247 DOLPHIN CT.
WILLET
RESIDENCE

PROJECT
PROPOSED ADDITION
DRAWING
EXISTING SITE PLAN

Dear Committee of Adjustments,

Thank you for reviewing our file. We are requesting to add an addition above an existing first floor.

PROJECT NO.
PLOT DATE: 4/7/2022
SCALE:
SHEET:
A-1

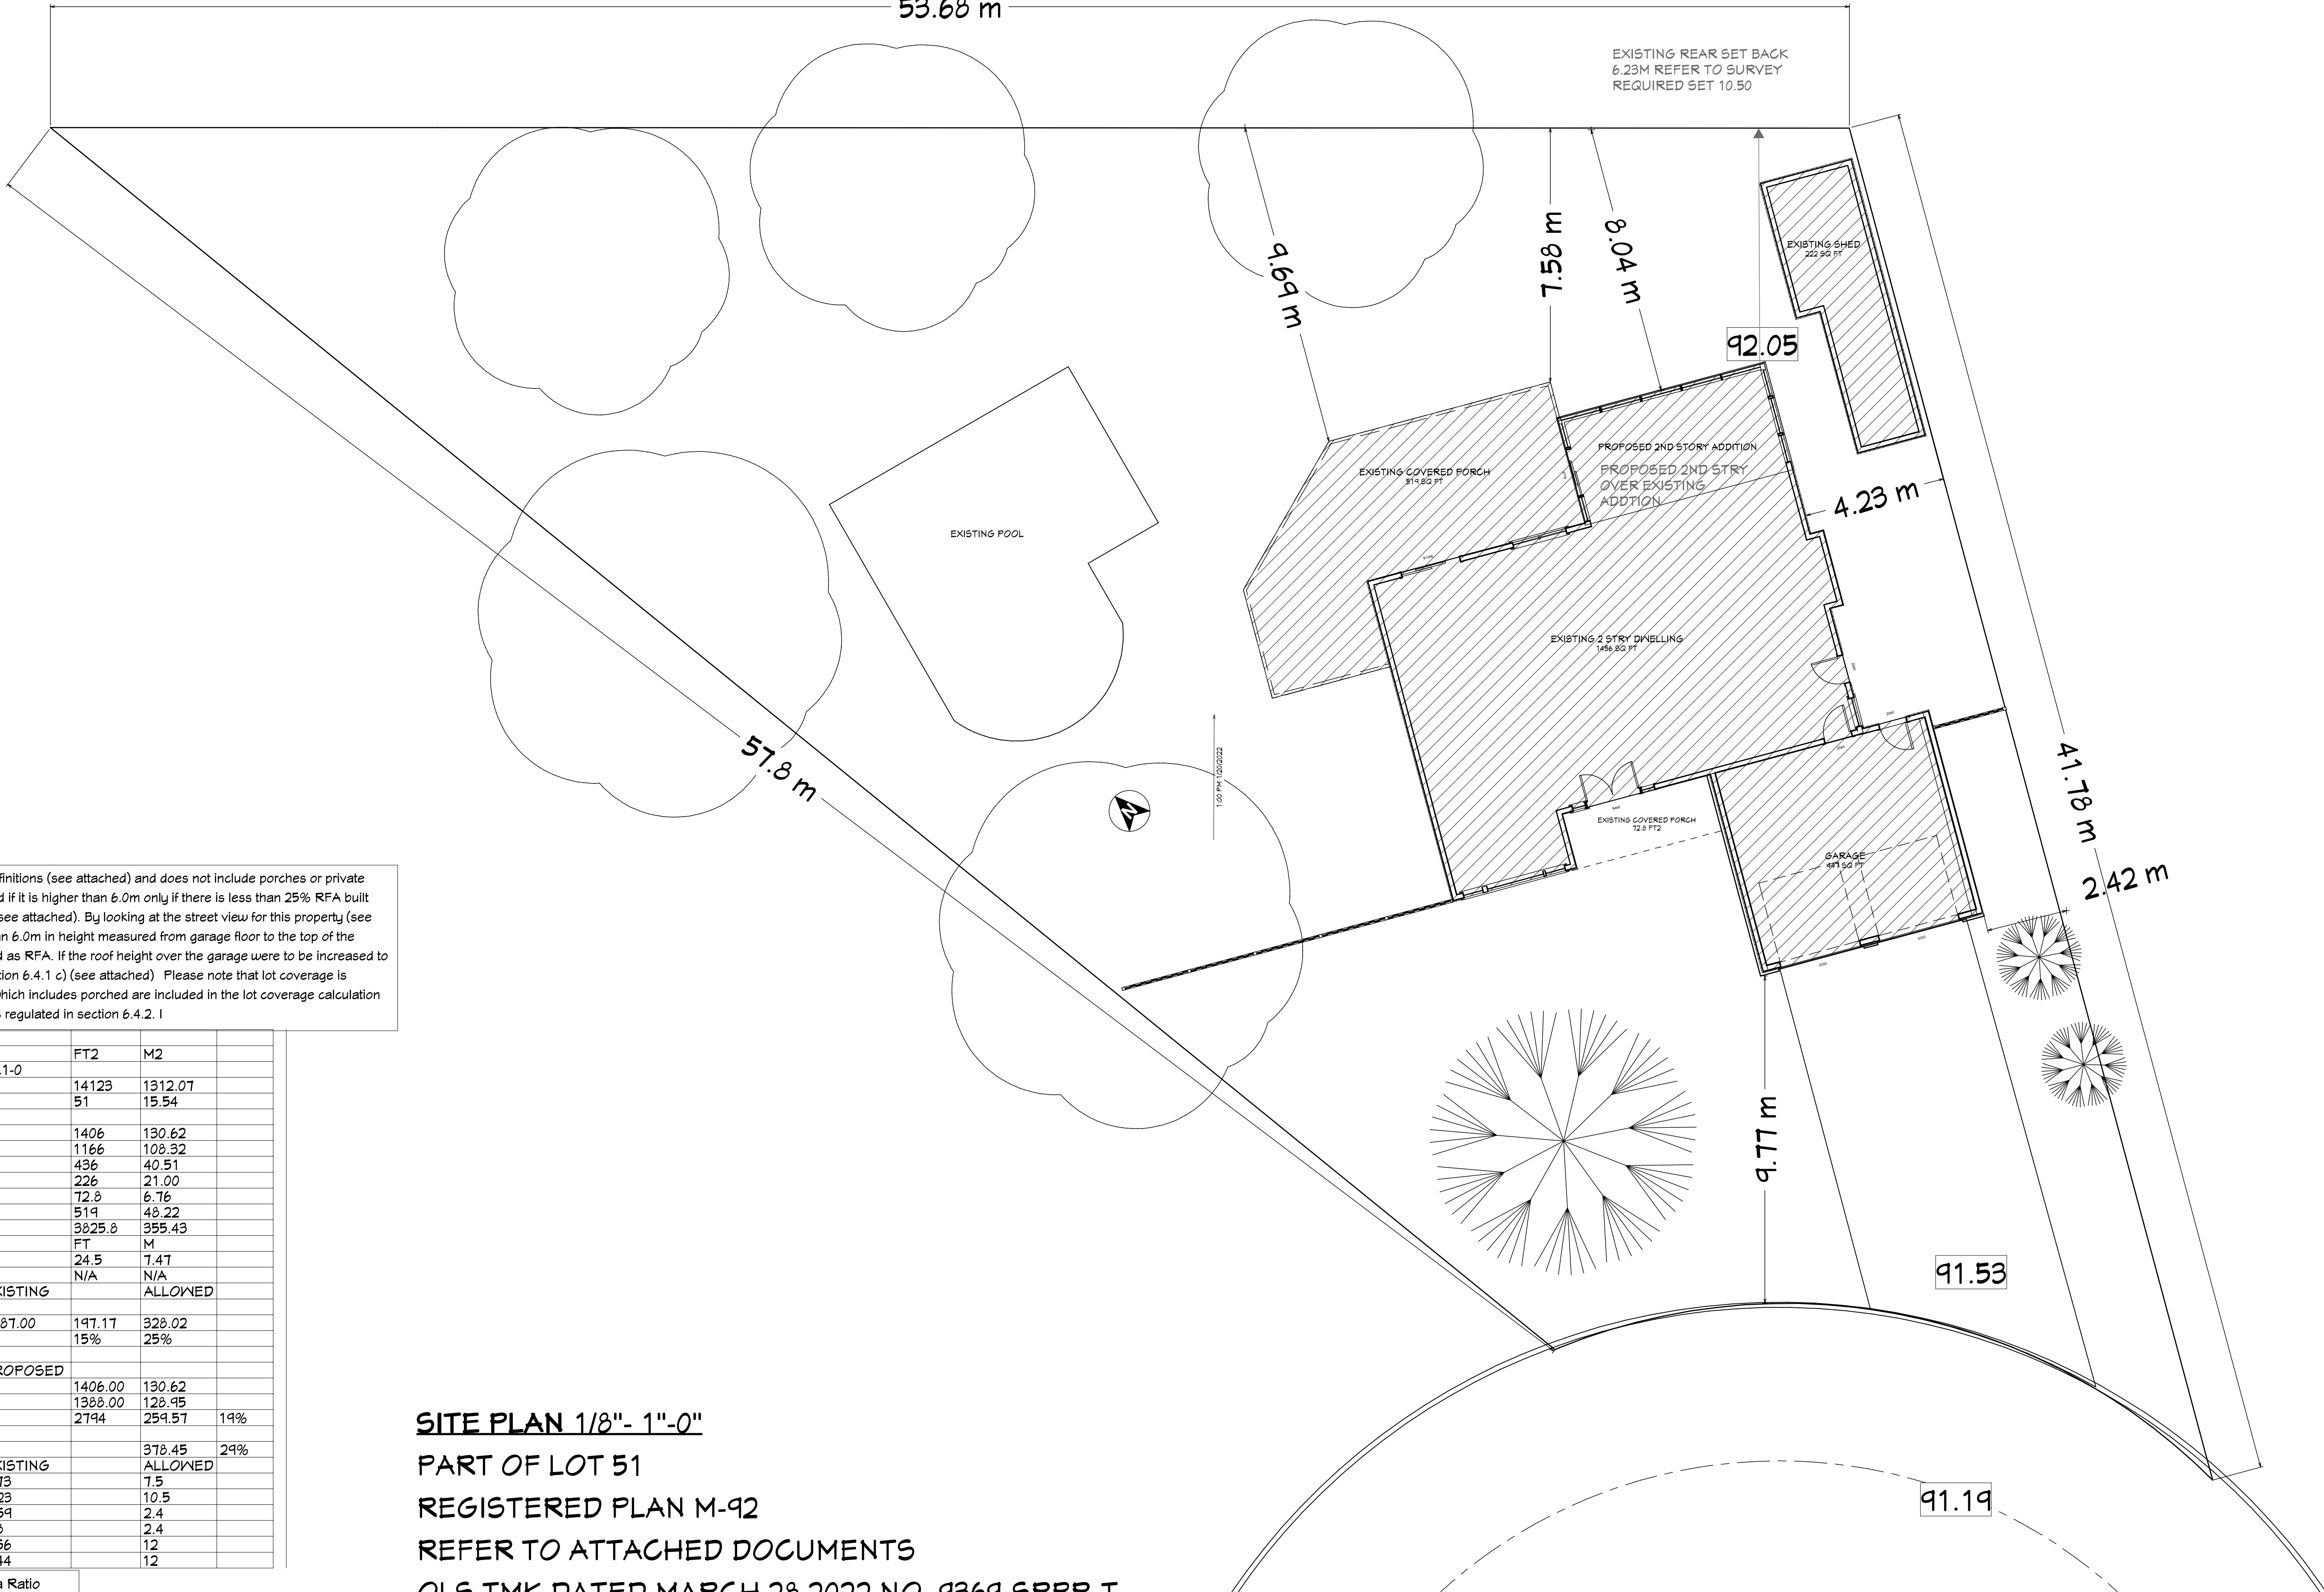
Residential Floor Area is defined under Part 3 definitions (see attached) and does not include porches or private garage unless the garage is higher than 6.0m and if it is higher than 6.0m only if there is less than 25% RFA built over the garage as regulated in section 6.4.1 c) (see attached). By looking at the street view for this property (see below) the existing garage appears to be less than 6.0m in height measured from garage floor to the top of the garage roof in which case it would not be counted as RFA. If the roof height over the garage were to be increased to 6.0m or greater then we would have to apply section 6.4.1 c) (see attached). Please note that lot coverage is regulated on this property. All roofed structures which includes porched are included in the lot coverage calculation which is 25% of the lot area in the RL1-0 Zone as regulated in section 6.4.2.1
